Addendum No. 3, June 11, 2025

Re: Johnson Hall Renovation – PKG 3
Johnson Hall Renovation & Foster Demolition
Tennessee Technological University
SBC Project No. 364/011-04-2022CM

From: Upland Design Group, Inc.
P.O. Box 1026 (38557)
362 Industrial Blvd.
Crossville, TN 38555
Telephone (931) 484 7541
Fax (931) 484 2351

3RD FLOOR REFLECTED CEILING PLAN

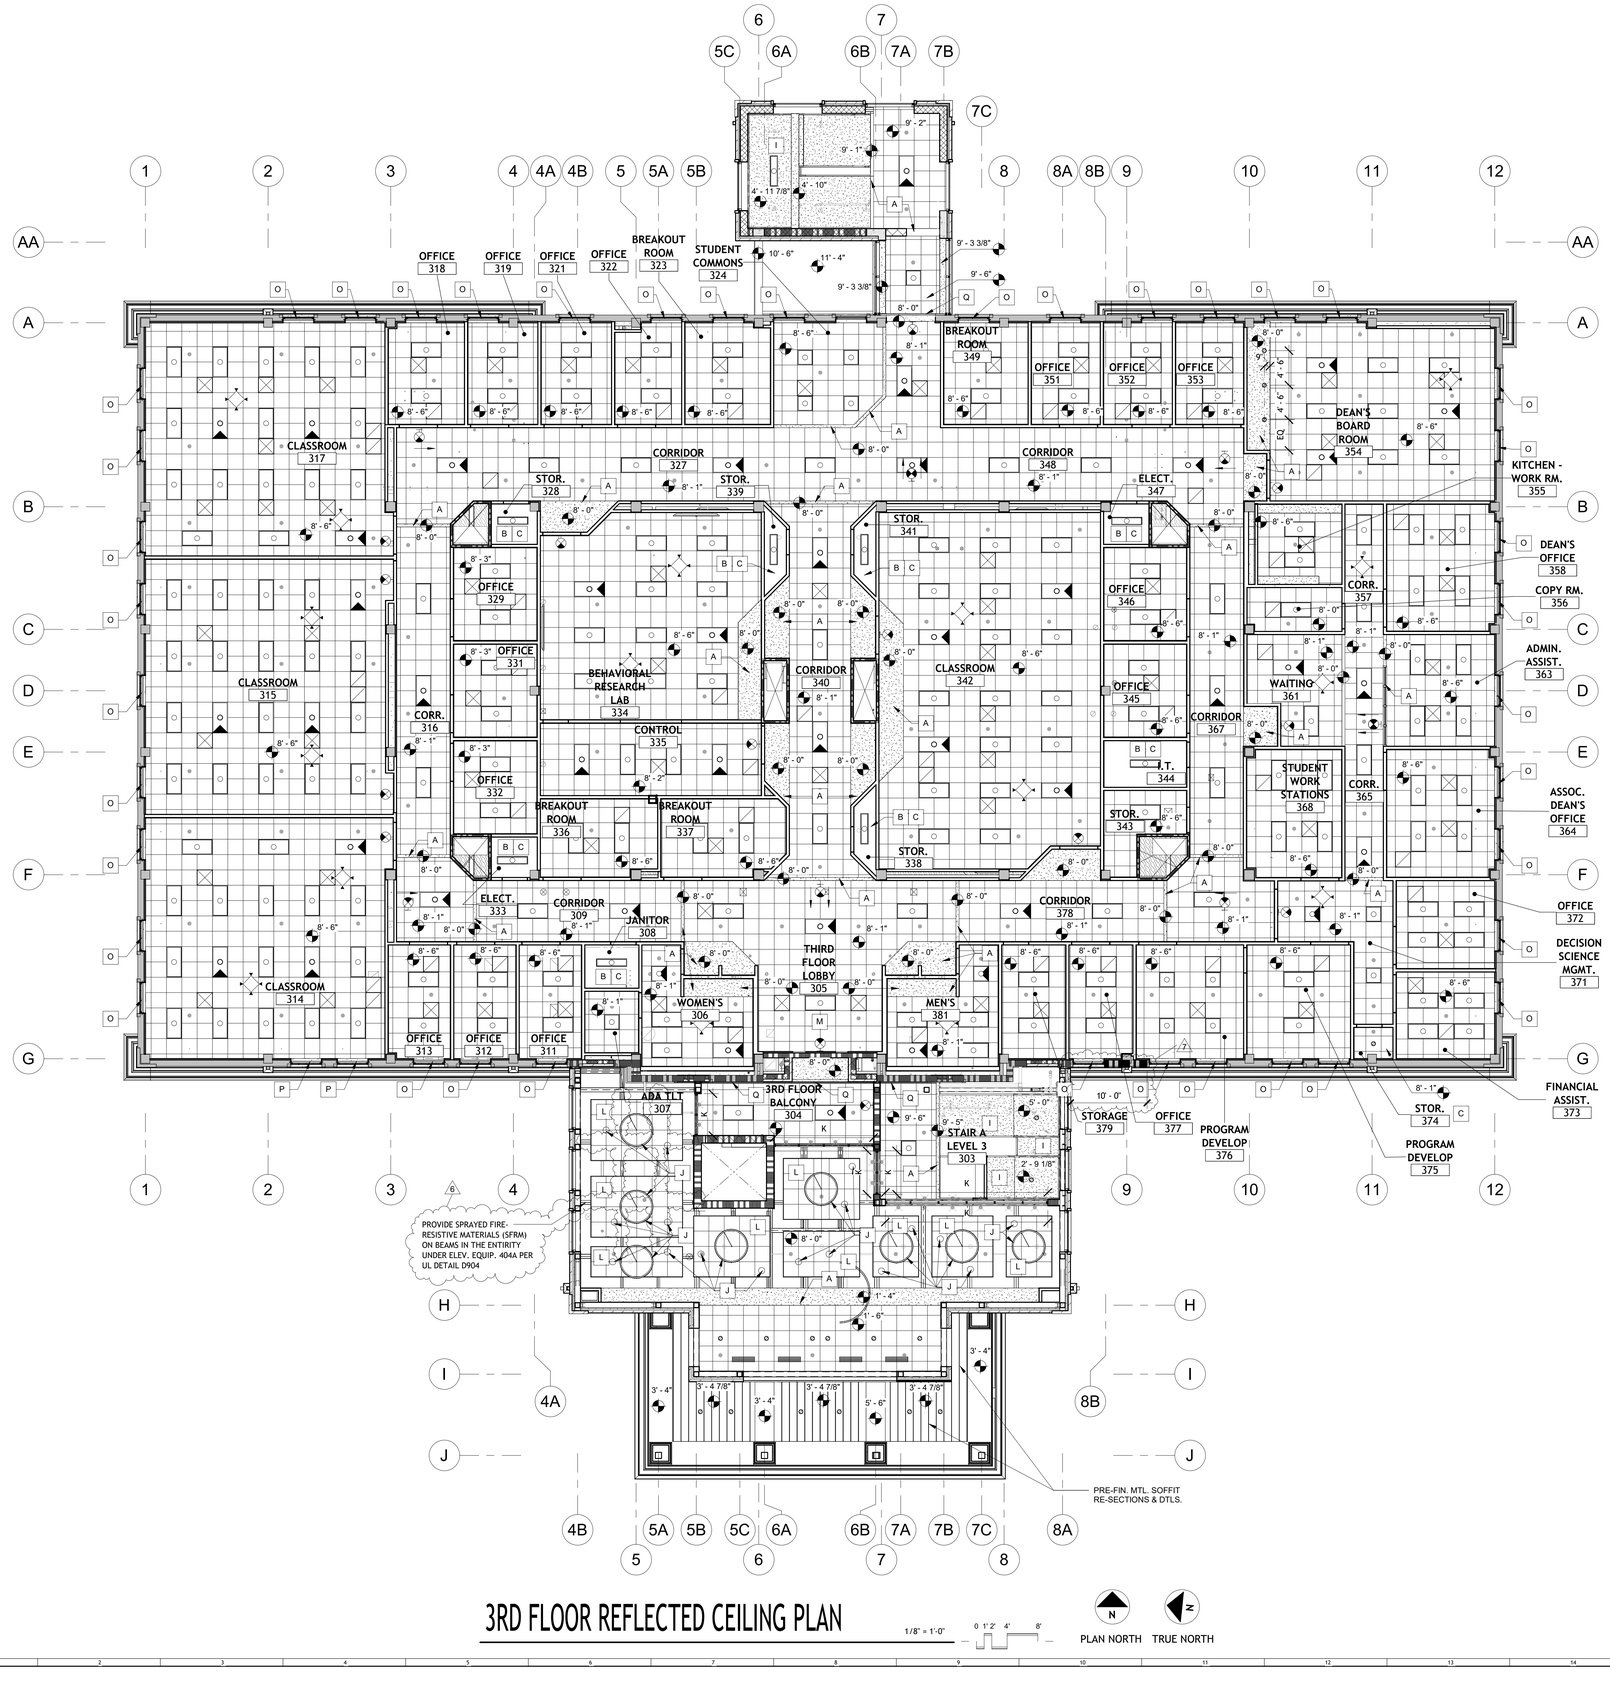
17) Refer to sheets A1.1D, A1.1N, A1.2D, A1.2N, A1.3D, A1.3N, A1.21, A1.22, A1.23, A1.31, A1.32, A1.61, A3.01, A7.10, A7.20, and A7.30. Add 1-hour fire rating to the first 10 feet of the plan east side of the new lobby addition per the attached revised sheets.

1 M1.1 FIRST FLOOR MECHANICAL PLAN

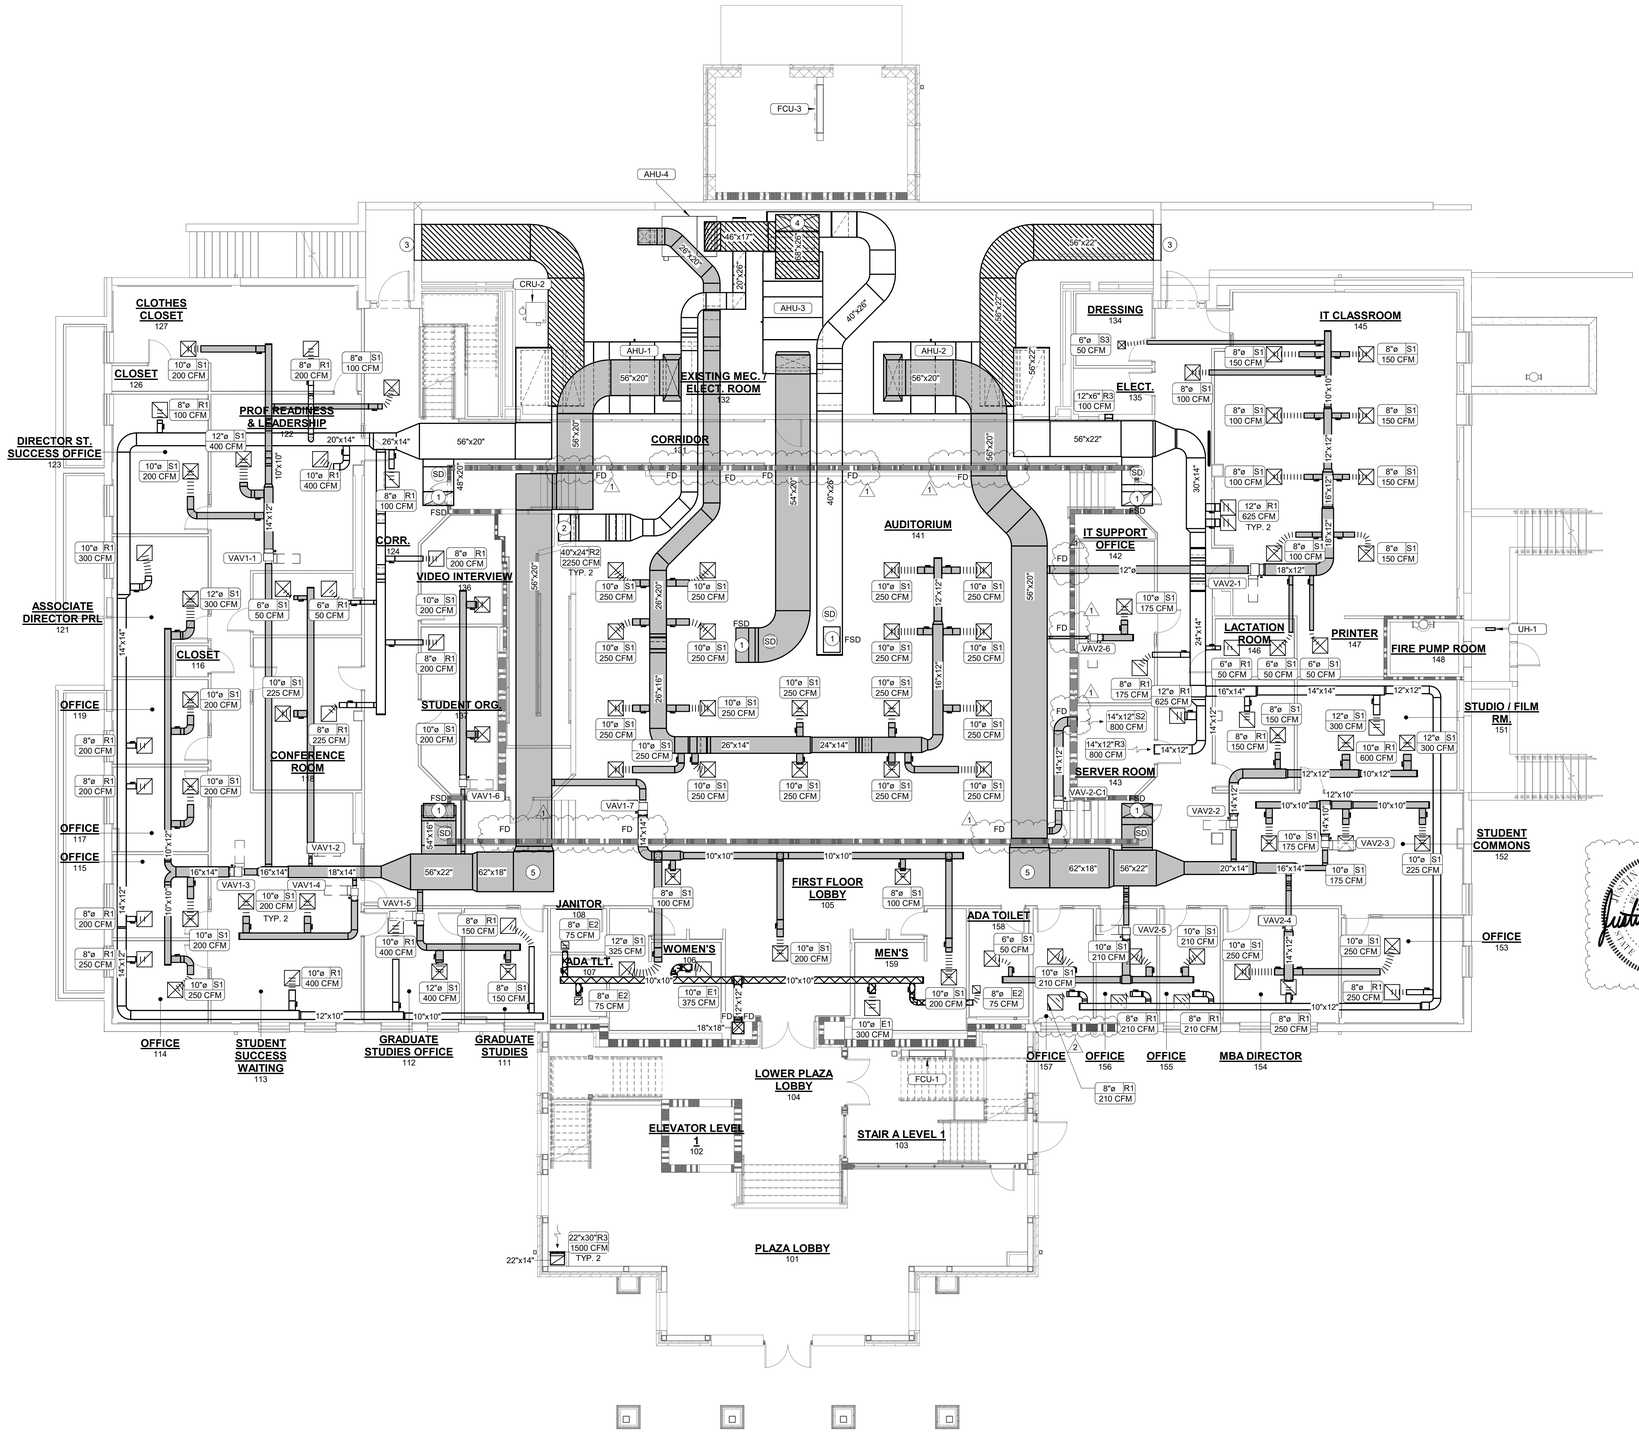
27) Refer to sheets M1.1, M1.2, M1.3, M2.1, M2.2, M2.3, P1.1, P1.2, P1.3, P2.1, P2.2, P2.3, FP1.1, FP1.2, FP1.3, FA1.1, FA1.2, FA1.3, E1.1, E1.2, E1.3, E2.1, E2.2, E2.3, T1.1, T1.2, T1.3, T2.1, T2.2, T2.3, T3.1, T3.2, and T3.3. Add 1-hour fire rating to the first 10 feet of the plan east side of the new lobby addition per the attached revised sheets.
